STUDER A730

Einführung neuer Servoelektronik
Introduction of new Servo electronics

SI 150/91

Order Nr. 10.85.7260 (Ed. 1191)

SERVO-BOARD 1.630.051.86

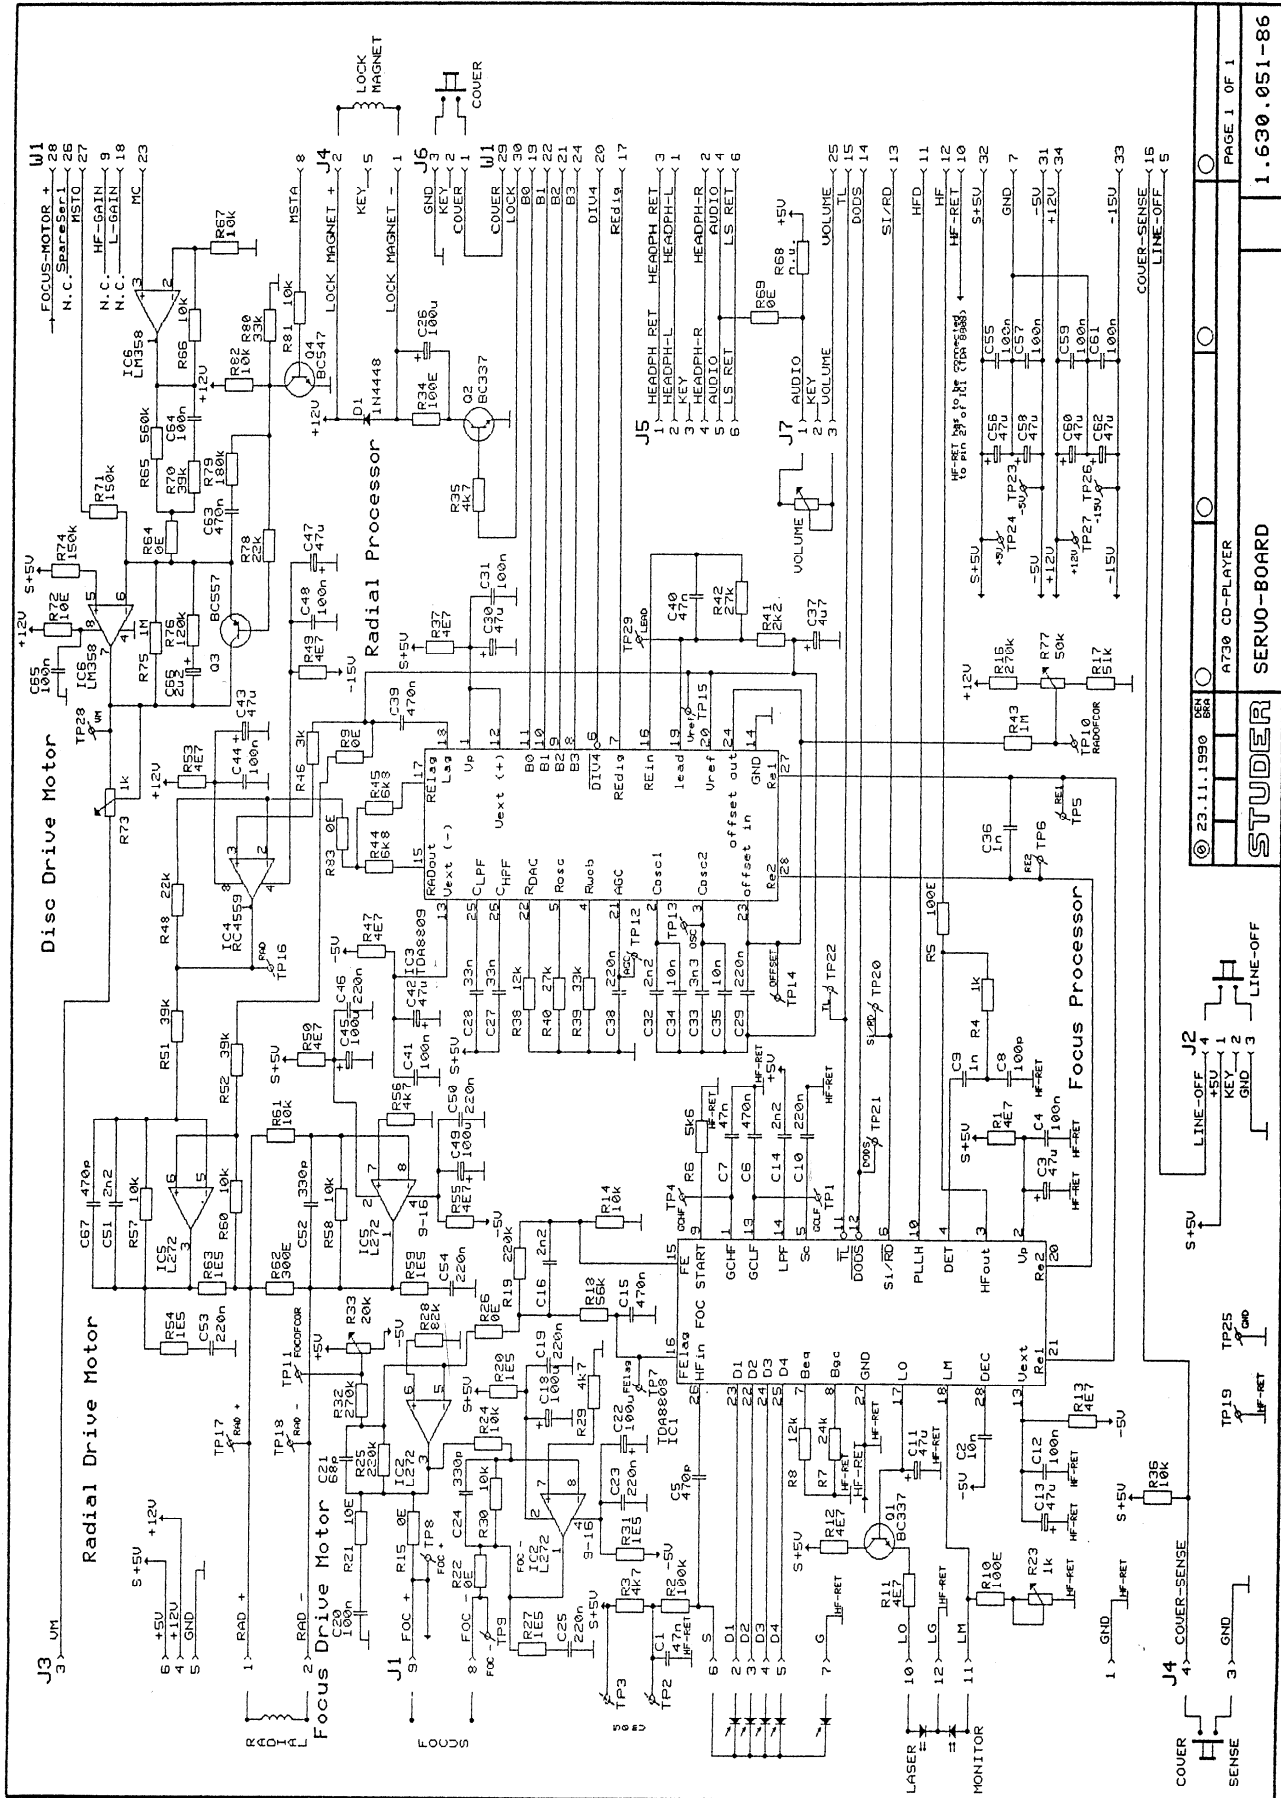
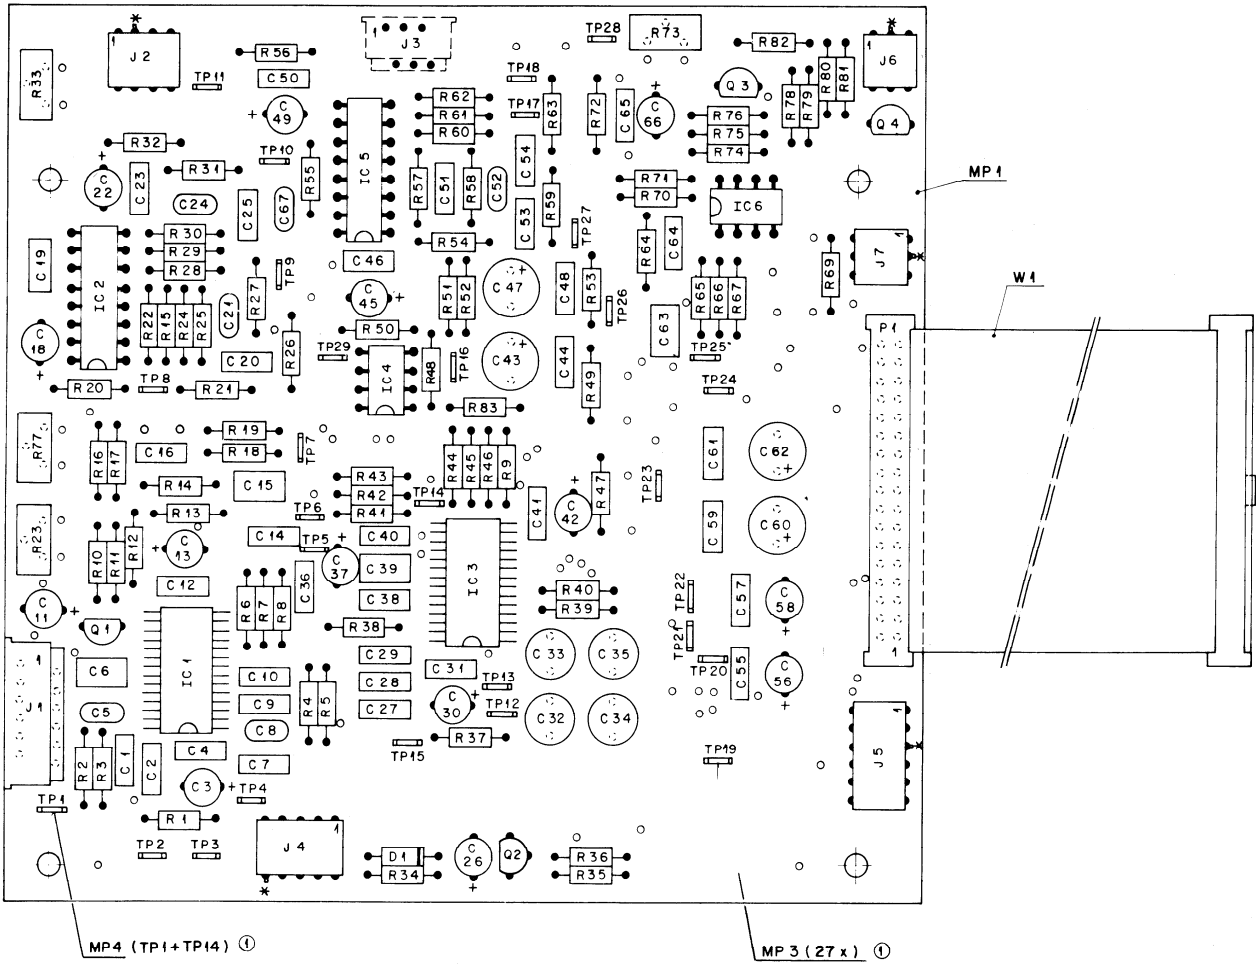
All previous versions of the SERVO BOARD must be replaced by the revised version 1.630.051.86.

MAIN BOARD 1.630.052.23

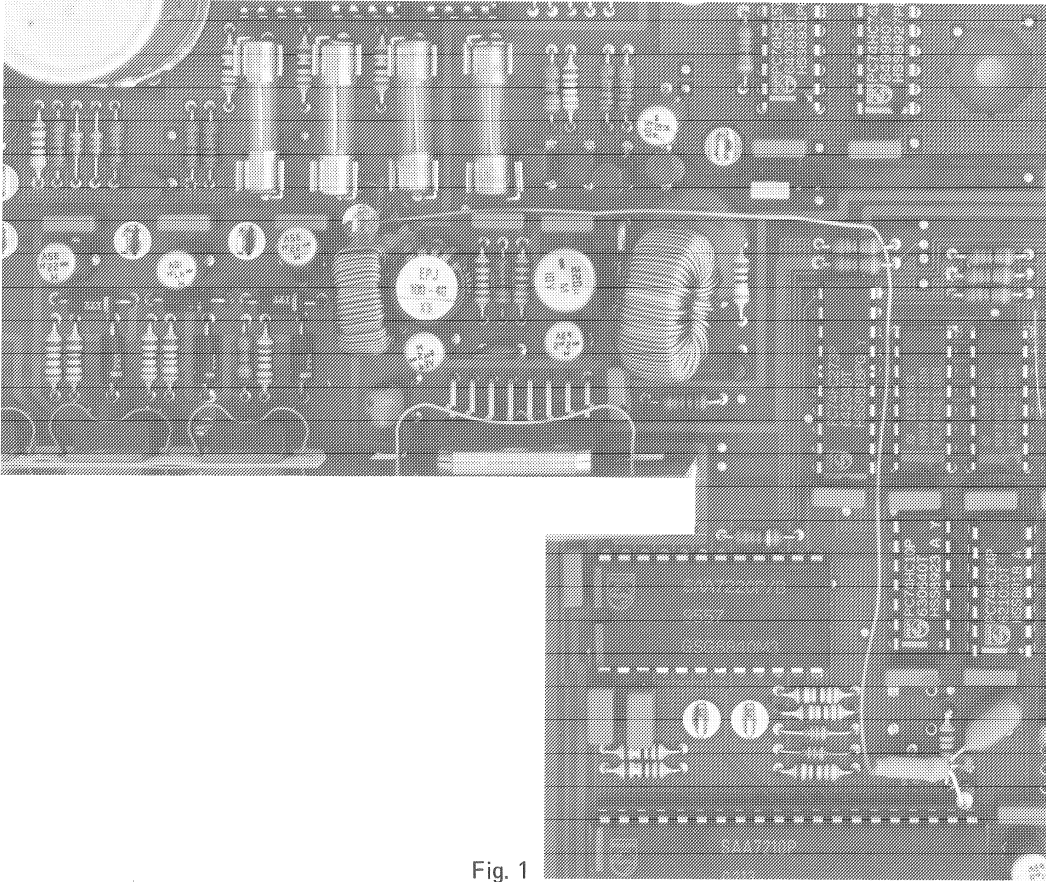
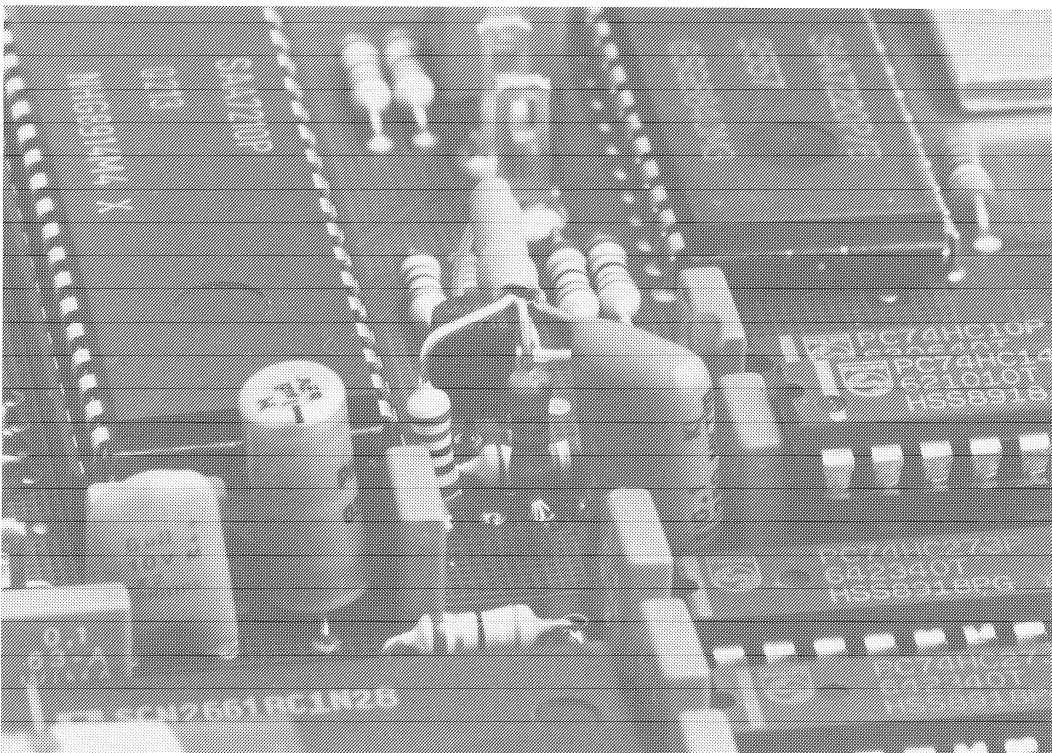
- Remove MAIN BOARD from the player
- Unsolder and remove R10 (3k3) and C29 (22n)
- The following components have to be changed:
 - R1 (1k) to be replaced with 2k2 (57.11.3222)
 - R8 (82E) to be replaced with 39E (57.11.3390)
 - R14 (3k9) to be replaced with 16k (57.11.3163)
 - R16 (680k) to be replaced with 220k (57.11.3224)
 - R9, R13 and C28 incl. wire wrap have been premanufactured and have to be installed acc. to Fig. 1 and Fig. 2 on page 17. The wire has to be connected to TP9 (+12 V).
- Replace potentiometer R147 by 4k7 resistor (57.11.3472) --> increased amplification in the monitor circuit
- Solder a capacitor 1n2 (59.32.2122) between pin 1 and 3 of the digital output (solder side) --> reduction of HF-emission
